2022/2406/P & 2022/3101/L 11 Regent Square

Delegated Dena	1		A nalvaja s			Evelen	Deter			
Delegated Report			Analysis shee		t	Expiry	Date:	01/08/20)22	
(Members Briefing)		1	N/A / attached			Consu Expiry	Itation Date:	21/08/20)22	
Officer					Application Nu	mber(s	5)			
Daren Zuk					2022/2406/P 2022/3101/L					
Application Add	iress				Drawing Numb	ers				
11 Regent Squai London WC1H 8HZ	e ·				See draft decision	on notid	ce			
PO 3/4 A	rea Teal	m Signature	C&UD		Authorised Off	icer Si	gnature			
Proposal(s)										
Proposed internal and external alterations including installation of stairlift from ground to second floor, internal lift from second to third floor, new doors to rear lower ground floor, and the extension of the rooftop tank room. (Amended description)										
Recommendation(s):		Grant conditional planning permission Grant conditional listed building consent								
Anniication IVno: I			Planning Permission ed building consent

Proposed internal and external alterations including installation of stairlift from ground to second floor, internal lift from second to third floor, new doors to rear lower ground floor, and the extension of the rooftop tank room. (Amend

Image 15: Proposed ground floor plan

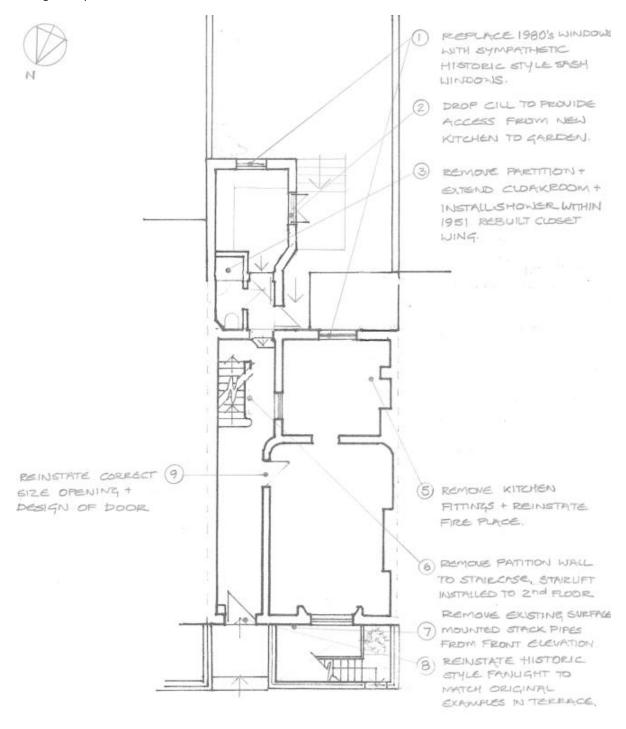
- 4.8. At the ground floor level, it is proposed to convert a window into a door in the closet wing, enlarge a lavatory in the closet wing, and move the kitchen from the back room into the closet wing. In addition, a stair lift will be installed from the ground floor to the second floor to provide wheelchair access for the occupier. The fanlight above the front door will be reinstated with a historically accurate fixture. The proposed alterations are considered small in scale and acceptable as they will not cause any harm to the significance of the listed building.

Image 17: Proposed second floor plan

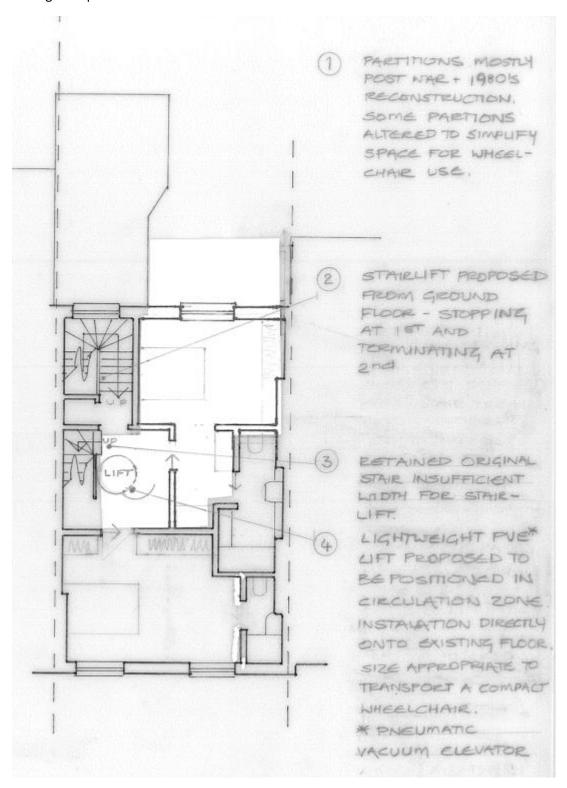
- 4.9. On the second floor, the floor plan appears to have been reorganized in modern times (likely during the WWII bomb damage reconstruction); thus reordering of the partitions is proposed. This is considered acceptable as the historic plan form will be reintroduced, thus enhancing the historic character of the listed building.

- 4.10. An internal tube lift is proposed between the second and third floors, which will provide access to these floors to the occupier. It is noted that because the floors between these two levels is of a modern construction the alterations will not further harm the heritage significance of the building and are thus supportable.

Image 19: Proposed roof plan

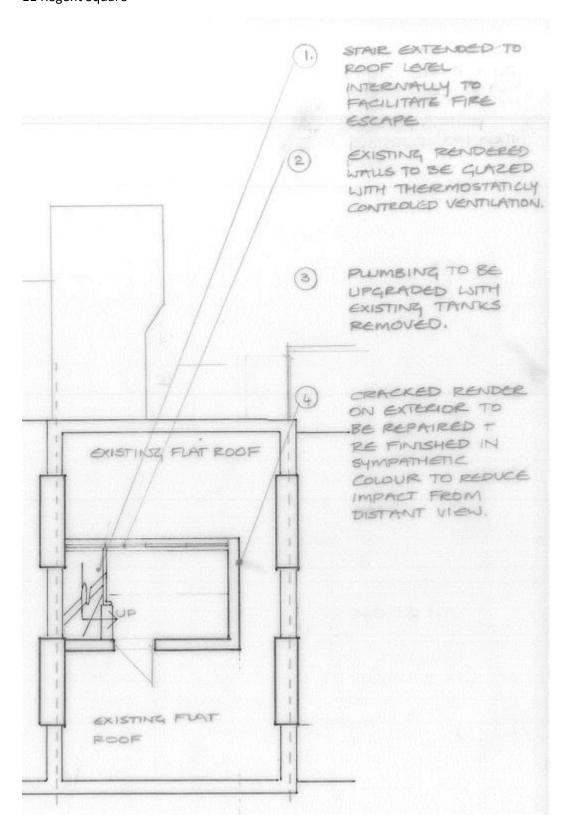
- 4.11. At roof level, the existing tank room is accessed from the second floor by a fire escape ladder. In order to provide a more accessible fire escape egress, a staircase is proposed to be installed connecting the second-floor level to the roof level. To facilitate this, the roof level tank room is proposed to be extended 1.0 metres towards the shared chimney stack with neighbouring no.10 Regent Square. The existing south facing rendered walls will be replaced with full height glazed panels with thermostatically controlled ventilation, and the render repaired/refinished. This is considered acceptable as the proposed changes will not be visible from the public realm and will therefore not impact the character of the listed building or of the wider conservation area. Access to the roof will be maintained, and a condition will be added to ensure the exterior of the roof level will not be used as a terrace.
